UNITED STATES PATENT AND TRADEMARK OFFICE

| APPLICATION NO. | FILING DATE | FIRST NAMED INVENTOR | ATTORNEY DOCKET NO. | CONFIRMATION NO. |
|-----------------|-------------|----------------------|---------------------|------------------|
| 10/763,985 | 01/23/2004 | Chang-Hyun Lee | 5000-1-507 | 8233 |

Office Action Summary

DETAILED ACTION

FIG.7

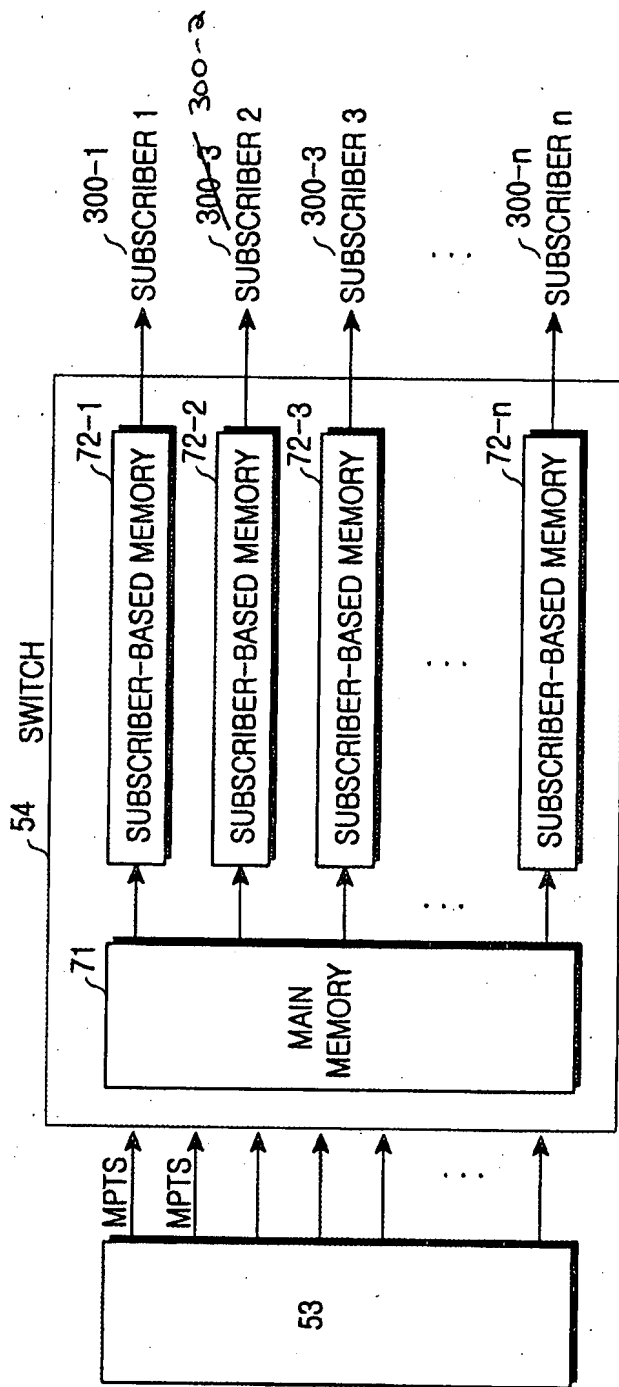
Notice the following limitation in parent claim 8:

“a plurality of secondary memory units having assigned storage areas for each of the MPTS data and the plurality of subscribers, wherein the **storage areas are** assigned according to the MPTS data in the first memory and **transmitted to each of the plurality of subscribers based upon the MPTS data in the first memory**” (emphasis Examiner’s).

These limitations correspond to Fig. 7 and p. 10, l. 8 – p. 11, l. 13 of the disclosure. Storage areas are not generally known to be *transmittable*. Rather, the MPTS data is transmittable. Furthermore, the disclosure does not support the transmission of storage areas. Accordingly, this limitation is not enabled. As a remedy, Examiner respectfully suggests amending the claim language so that the MPTS **data** is transmitted instead of the storage areas.
